**CITRUS COUNTY
CLASS I LANDFILL
OPERATION PERMIT RENEWAL
RESPONSE TO FDEP RAI#2**

Permit No.: SO09-274381

Response to the Florida Department of Environmental Protection
Request for Additional Information #2
September 2001

SITE PLAN

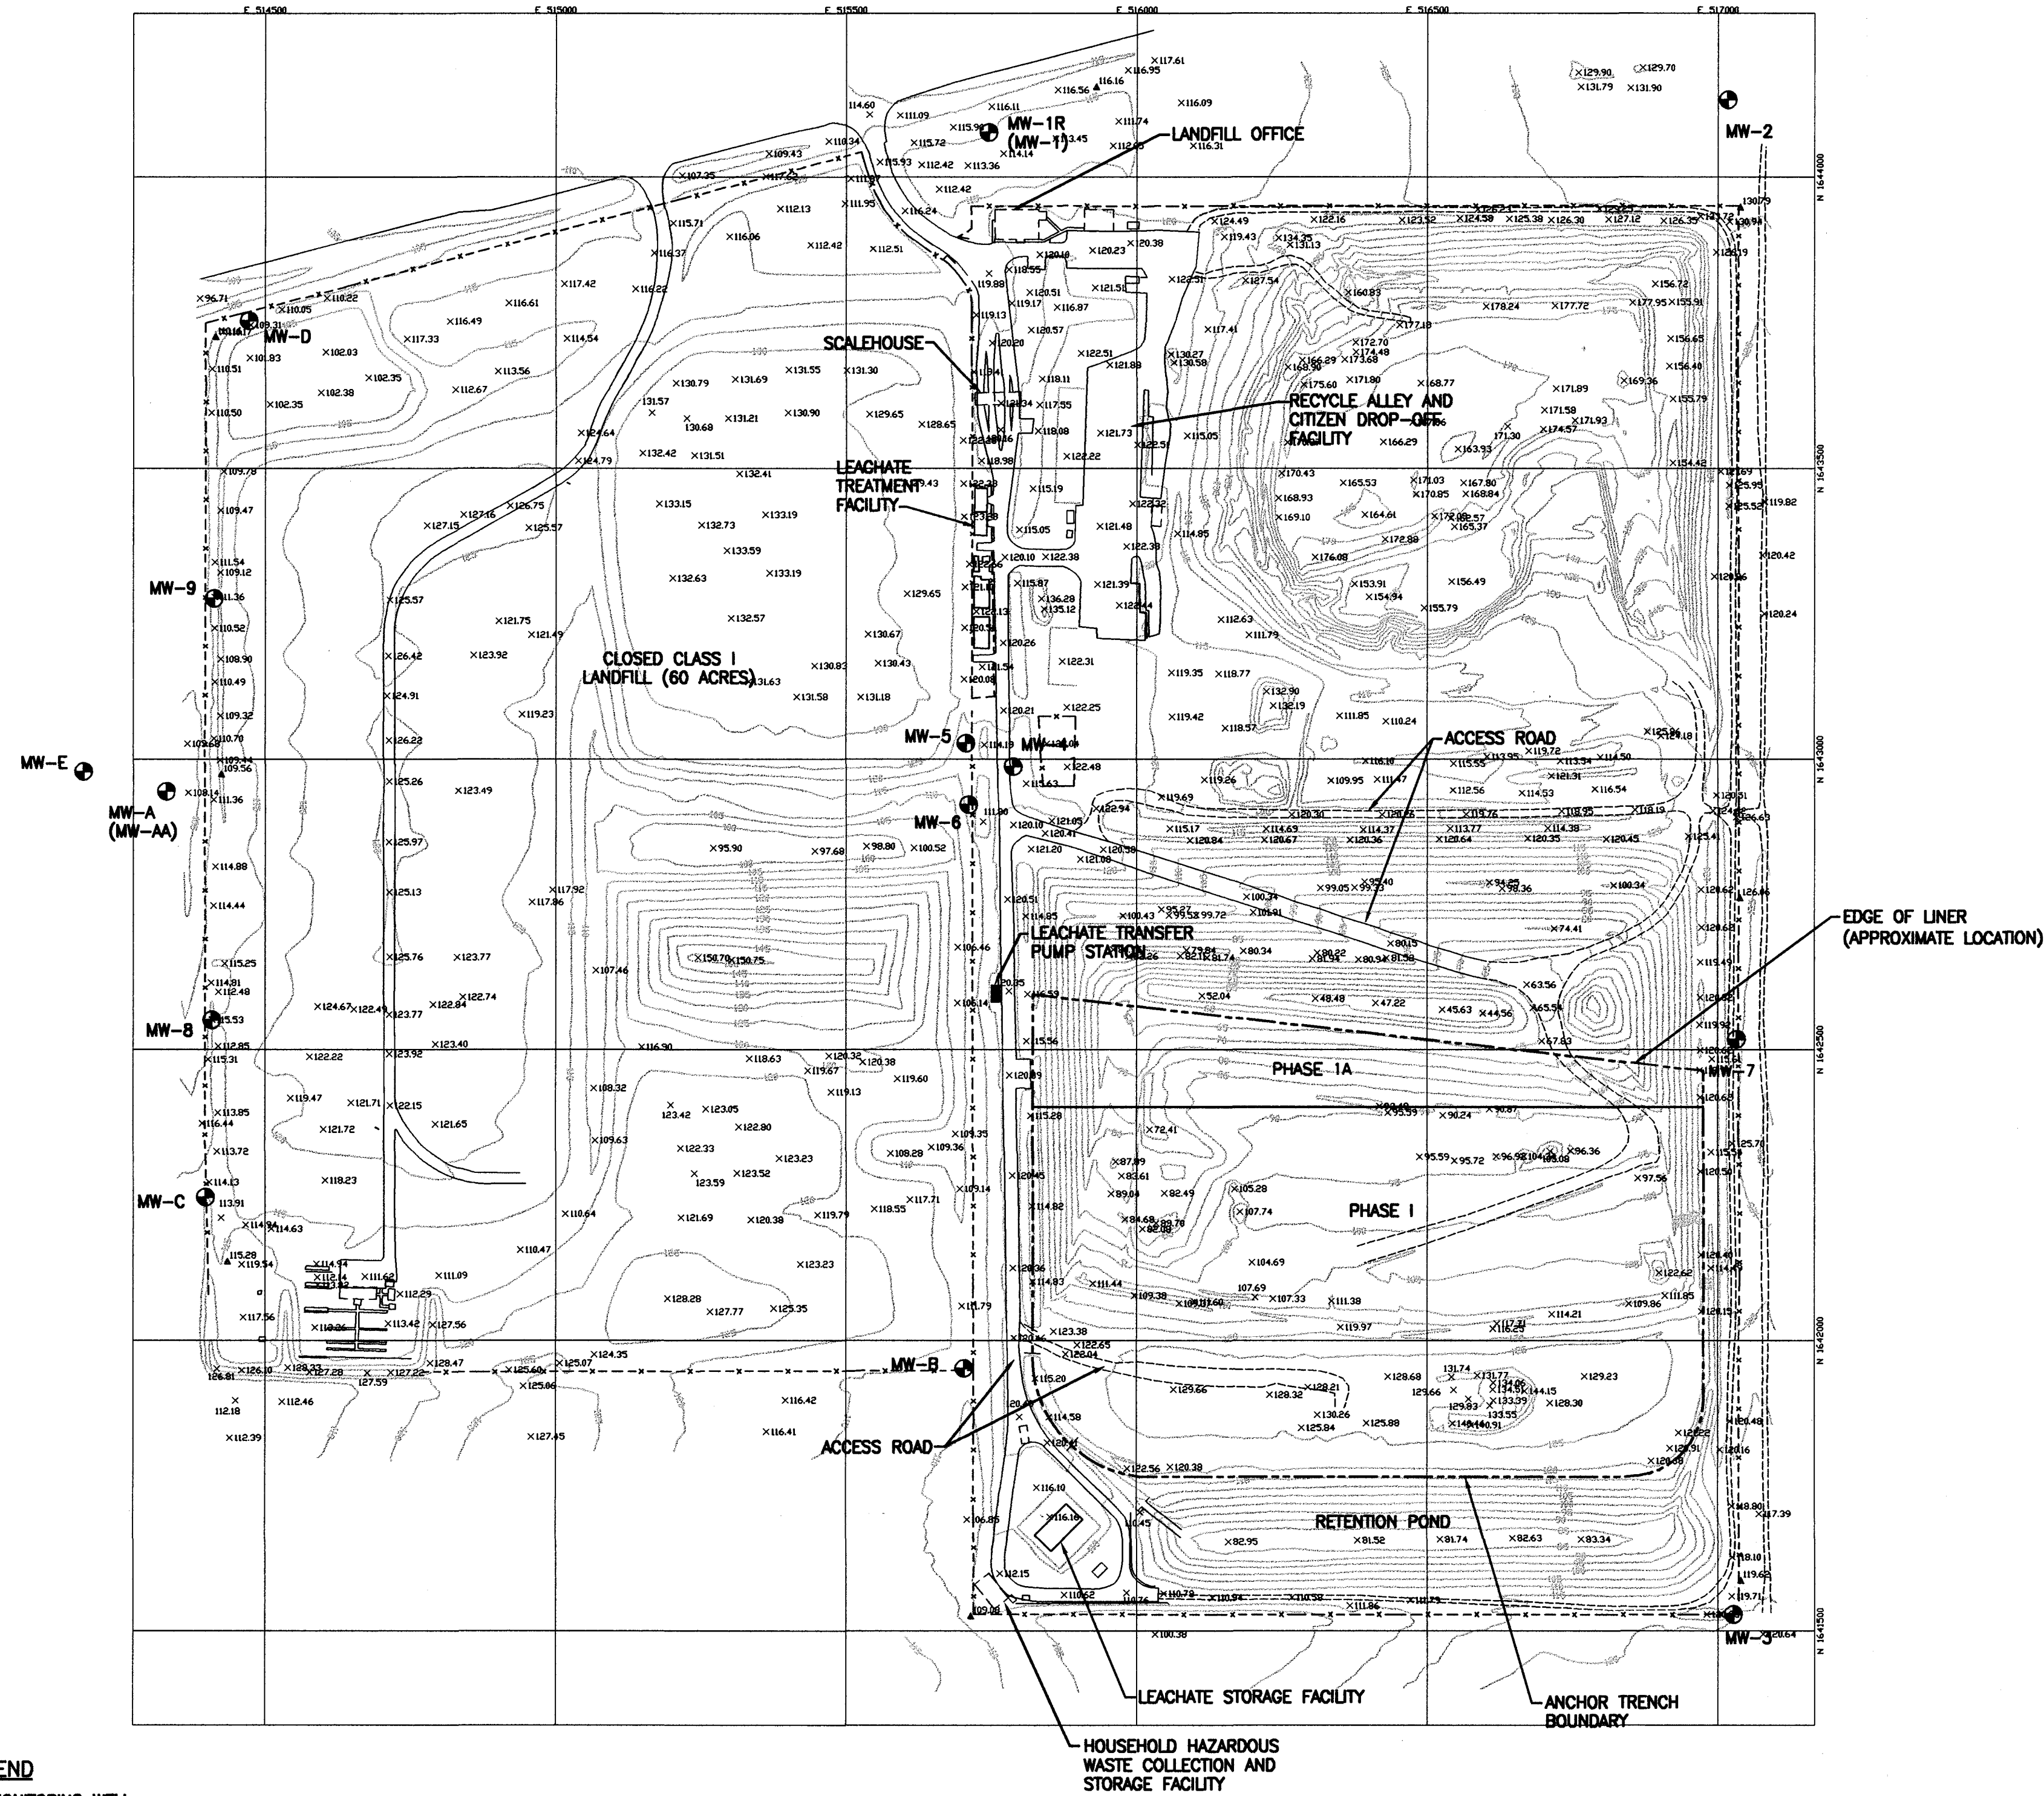
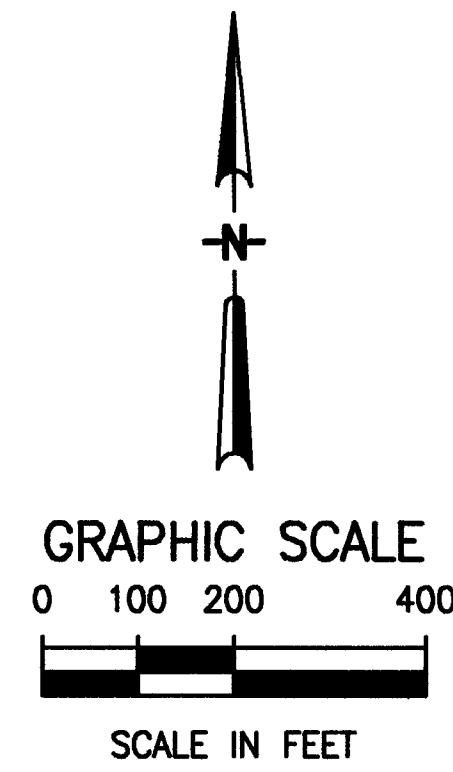
Comment 1: 62-701.330(3)(d). One set of full-sized site plans referenced in Jones Edmunds' response dated July 2001 were not provided. The one sheet entitled Site Plan needs to be signed and sealed.

Response 1: The signed and sealed Site Plan is provided as Attachment 1.1.

Figure 9-1
Gas Monitoring Probes

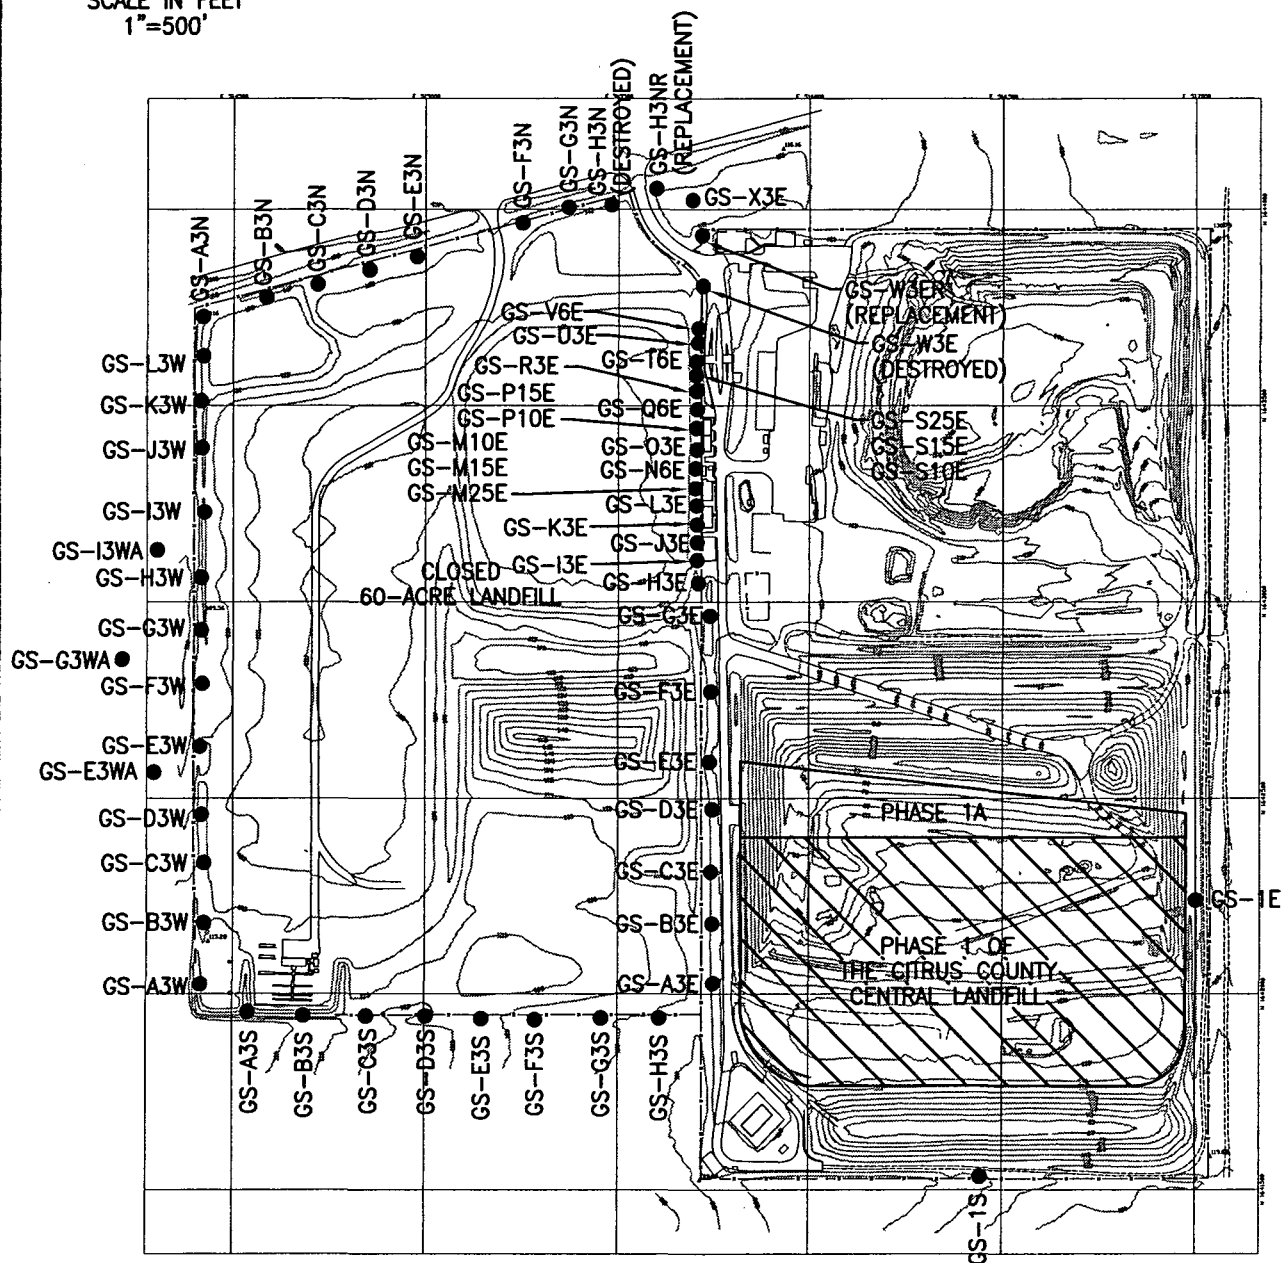
Comment 6: 62-701.500(9). 1) Clarification is requested for the reference to "this" LFG Monitoring Program. Is "this" program the one received in October of 1996? 2) Revisions are needed to correctly describe the construction and depth of the gas probes. According to previous descriptions, not all probes are 3 feet or 80 feet deep. 3) Is Figure 9-2 the construction detail for all probes or GS-1S and GS-1E only? 4) Does the gas measurement device provide direct reading in % LEL, or is a calculation required for conversion to % LEL?

2) The following table lists the gas monitoring probes and their respective depths. See Figure 9-1 of the previously submitted Citrus County Central Landfill Operations Plan, prepared by Jones, Edmunds & Associates, July 2001, for the locations of the gas monitoring probes.

3) Figure 9-2 of the previously submitted Citrus County Central Landfill Operations Plan, prepared by Jones, Edmunds & Associates, July 2001, shows the well construction of the 80-foot probes.
